SUNDRY NOTICES AND REPORTS ON WELLS

8. Well Name and No.
Chacon Jicarilla 602H

Energen Resources would like to make the following changes to the Chacon Jicarilla #602H.

Drilling Plan
Energen Resources Corporation
Revised 8/03/2015

Plan: Design #2

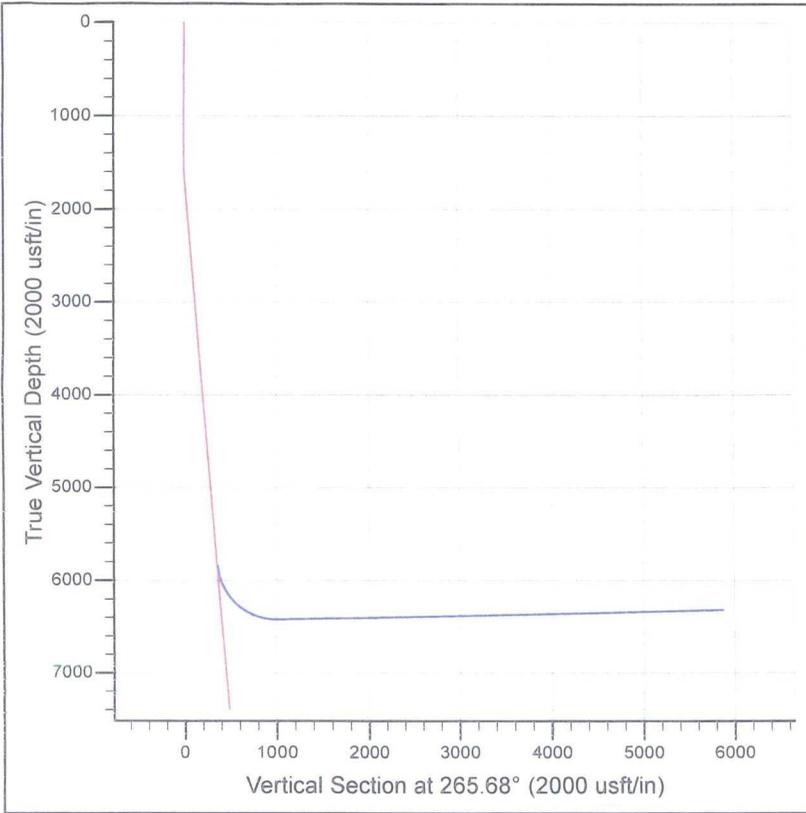
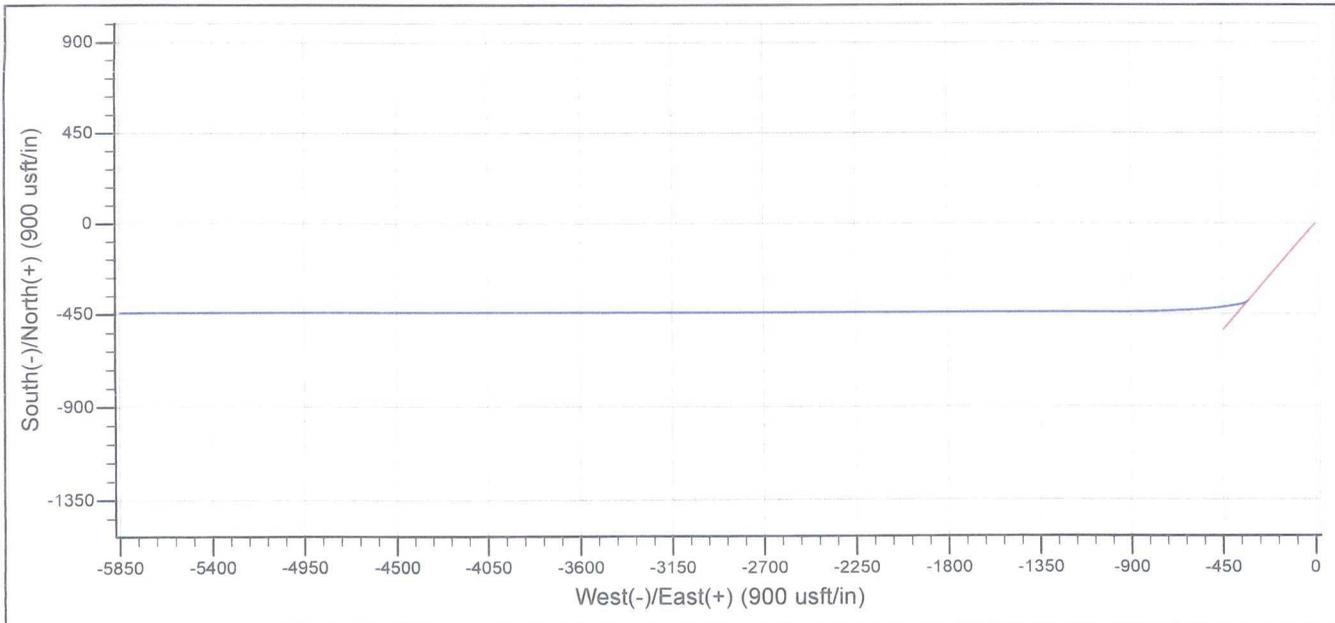
-Change the Direction Plan for the pilot hole formation evaluation.

Attached is a revised drilling operations plan and directional plans depicting this change. The cement plug back procedure will follow on form 3160-5.
